Land to the South of Huntsland and West of Turners Hill
Road, Crawley Down (DM/25/0014 and DM/25/0015)

Transport Assessment Addendum

Client: Wates Developments Ltd

Date: 26 March 2025

Image 2.1: Southern access junction and proposed toucan crossing

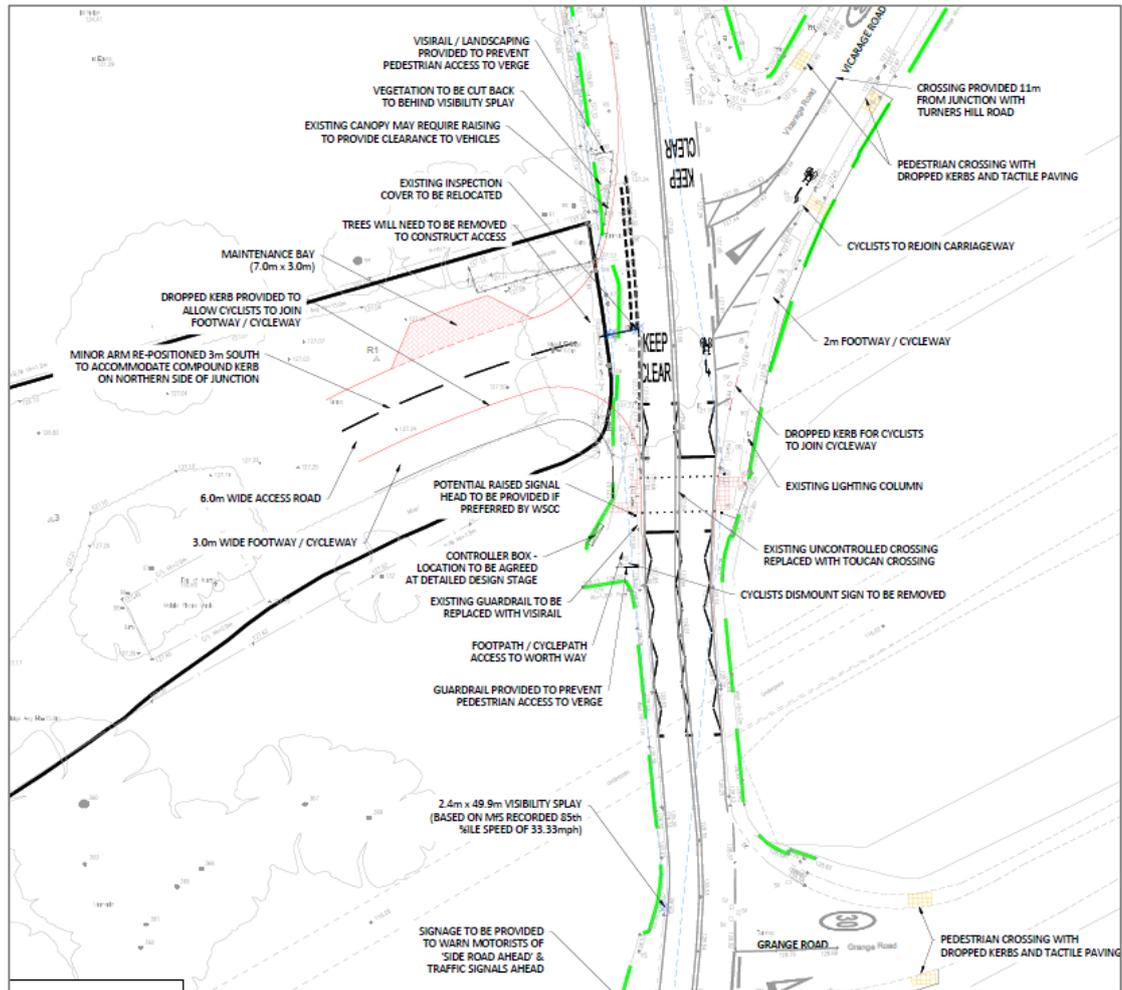
- 2.3 Paragraph 8 requests an updated RSA of the southern site access which includes the signal-controlled crossing. This is included as **Appendix D**, while an updated drawing taking on board the recommendations of the audit is included as drawing ITB9155-GA-029J. The Design Team Response, prepared in accordance with Appendix F of GG119, is included as **Appendix E**. The form will be issued separately as a word file to enable the inclusion of comments from WSCC, as the Overseeing Organisation

2.6 Paragraph 9 requests a response to the following questions from WSCC signals team. A response to the questions is provided, based on the audited drawing.

Question	Response
<p>A crossing should be located a minimum of 20m from a conflict point with a side road. Can the separation be clarified.</p>	<p>The crossing is 14m south of the centre line of the next junction to the north.</p> <p>There is no minimum clearance distance between a crossing and a junction – the relevant design standard - Traffic Signs Manual Chapter 6 - recommends that there is sufficient space for at least one waiting vehicle. It also advocates striking a balance between giving drivers time to move away from a junction and brake and minimising deviations from pedestrian desire lines (<i>ref: para 15.12.1 and 3</i>).</p> <p>A 14m gap is more than sufficient for a typical car (usually no more than 5m long) to wait at the stop line. The separation available also minimises deviation from pedestrians’ or cyclists’ desire lines.</p> <p>The crossing cannot be located further south because the carriageway and footway is constrained by the width of the bridge. Root protection areas prevent the siting of a footway (and therefore crossing) on the northern side of the junction. The crossing is around 4m from where the existing uncontrolled crossing is located and is a significant improvement on it. There is no scope to relocate further from the junction.</p>

Question	Response
<p>There is a comment on the drawing stating the width behind a signal pole of 0.79m. This distance is substandard; the absolute minimum required is 1.2m, however our preferred minimum is 1.5m to enable wheelchairs/pushchairs to safely pass.</p>	<p>This is no longer applicable The latest access drawing shows a 2m clearance behind the pole. The hardstanding will be widened using highway verge behind the existing footway. 2m exceeds these minima and is an acceptable shared cycle route width (<i>ref: LTN 1/20 Table 7-2</i>)</p>

Question	Response
<p>There are a number of established trees which have the potential to impact approaching driver & waiting pedestrian visibility. A green man is only an invitation to begin crossing, and pedestrians should be able to see the approaches clearly; anyone crossing from West to East may have challenges observing southbound traffic flow</p>	<p>Whilst DMRB / TSM Ch. 6 includes no requirement for visibility to / from waiting pedestrians at signal-controlled crossings – the key test is driver visibility to signal heads - visibility splays between a pedestrian waiting to cross on the western side of the road and oncoming vehicles can be achieved to the stated stopping sight distance (<i>ref: Appendix F</i>).</p> <p>The sightline towards a pedestrian on the western side passes very slightly under the canopy of a tree. However, in order to secure visibility between vehicles and pedestrians, the sight line must be retained at a height of under 2m. The canopy does not extend this low, although it will need to be maintained to secure continued visibility.</p> <p>Again, it is important to note that the proposed signal-controlled crossing is a significant improvement on the existing crossing arrangement at this location, benefiting not only residents of the proposed development but existing users of Worth Way and the wider Crawley Down community.</p>

Question	Response
<p>Every signalised crossing requires street lighting, and there does not appear to be suitable locations to install lighting columns. This would need to be checked with the authorities PFI provider, to ensure the proposed crossing can be suitably lit</p>	<p>There is street lighting at the junction with Grange Road and on Vicarage Road. The crossing does not appear to be any more remote from lighting than the signal-controlled crossing by Huntsland. The level of lighting of the column is acceptable and the puffin crossing to the north, which is similarly sited in relation to lighting columns, sets a local precedent.</p>
<p>It is important to identify the proposed location for the signals controller and location for a maintenance bay.</p>	<p>A maintenance bay is identified adjacent to the proposed access road. The controller box can be provided immediately south of the signals, and is indicatively shown on drawing ITB9155-GA-069A. The matter can be confirmed at the detailed design stage.</p>

- 2.4 The key recommendation arising from the audit is to upgrade the crossing from a puffin to a toucan, in order to facilitate cycle access across Turners Hill Road. The recommendation has been accepted by the Design Team, and a toucan crossing has been proposed. To the west of the crossing, the shared cycleway south of the access will be extended as far as the crossing and Worth Way. To the east, a 2m shared cycleway (an acceptable width where constraints are present (*ref: LTN 1/20 Table 7-2*) will be provided between the crossing and the southern end of Vicarage Road, with dropped kerbs allowing cyclists to leave the carriageways of Vicarage Road and Turners Hill Road.

- 2.5 This is also a significant improvement of the existing crossing arrangements that will benefit pedestrians emerging from Worth Way. At present, they must use an uncontrolled dropped kerb / tactile paving crossing at approximately the same location as the proposed signals. The signals will improve driver awareness of a crossing ahead while allowing pedestrians (and cyclists) to cross with priority over oncoming traffic.

Image 2.2 – Revised central access with toucan crossing

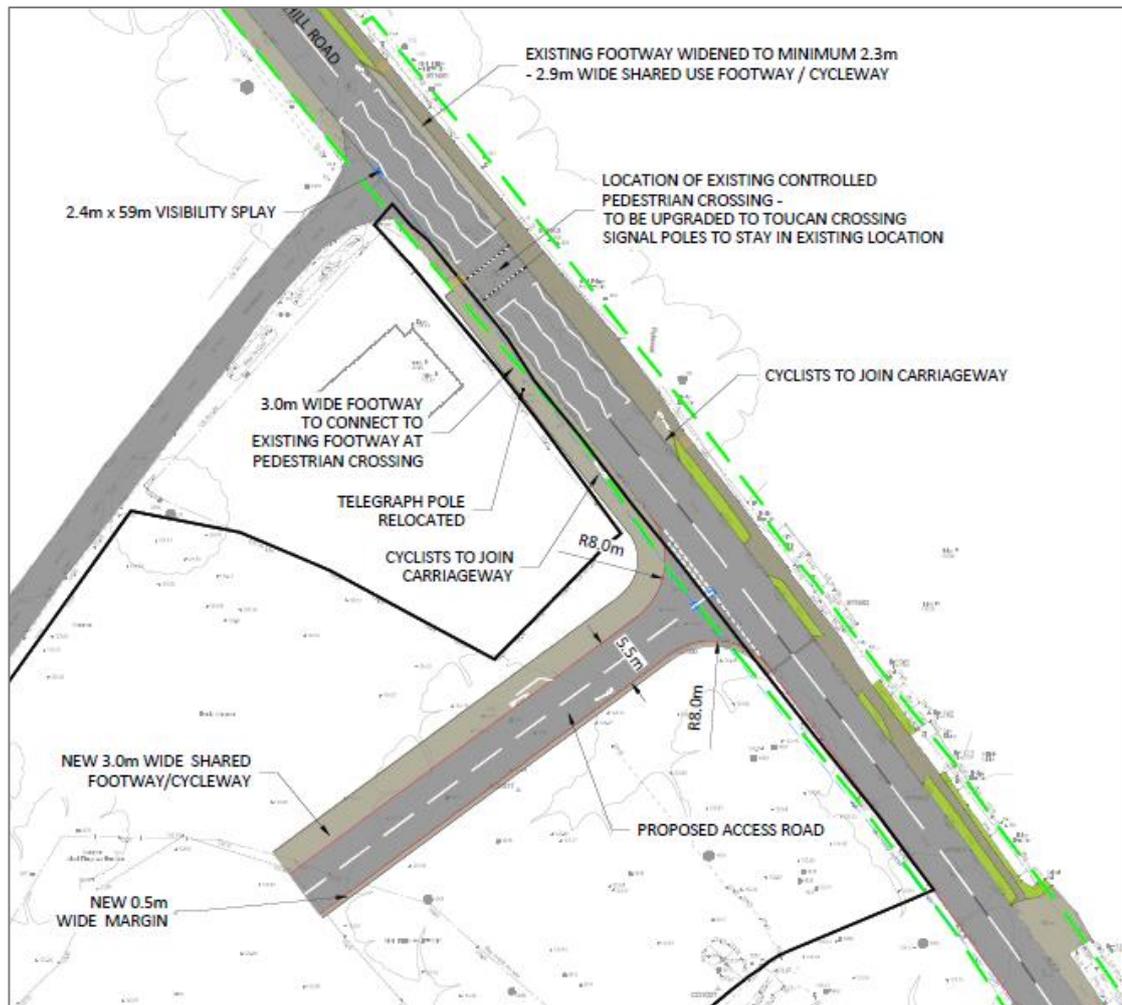
2.15 Paragraph 13 requests continuity for cyclists across the B2028 from the central access. Accordingly, an updated drawing is provided as drawing ITB9155-GA-038I, showing 3m cycleways along the access and extending as far as a new toucan crossing (where the existing puffin crossing is located) and then leading to short sections of cycleway of 2.1m to 2.4m (exceeding LTN1/20's minimum of shared cycleways) on the eastern side. The widening is provided by converting a short section of verge to footway, which end at dropped kerbs where cyclists can rejoin the carriageway. The drawing is presented as an alternative to the vehicle access drawing at drawing ITB9155-GA-038H. Its purpose is to enable cyclists to cross the B2028 Turners Hill Road with priority over traffic, consistent with the objectives of paragraph 115(a) of the NPPF, rather than wait at the give way line. The crossing will aid less confident cyclists. The revised access arrangement is illustrated below.

2.16 Paragraph 14 requests an editable Designer's Response. This will be provided separately as a Word document. It should be noted that the Safety Auditor has been informed of the proposal to provide a toucan crossing north of the central access and provided with an updated drawing. The Auditor has raised no additional safety comments related to the change to the proposed arrangements. A letter from the Auditor is provided at **Appendix H**. It raises detailed comments for consideration at detailed design stage but no in-principle safety concerns not considered through the earlier audit.

Image 2.3: Crossing point on Vicarage Road

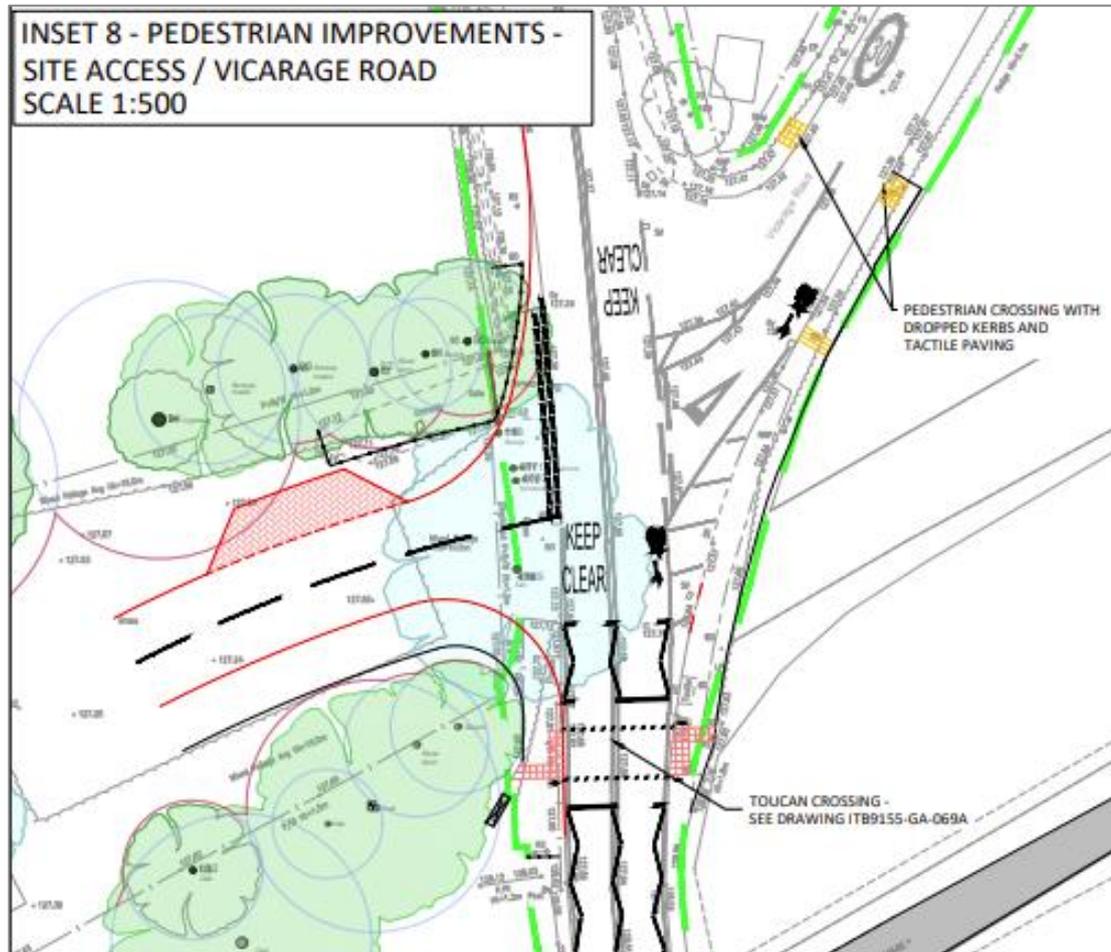
2.21 Paragraphs 20-24 recommend the following changes to the off-site highway improvements, which are also illustrated in drawing **ITB9155-GA-056C**:

- The crossing point on Vicarage Road has been relocated further from the junction with Turners Hill Road (*ref: paragraph 15*):
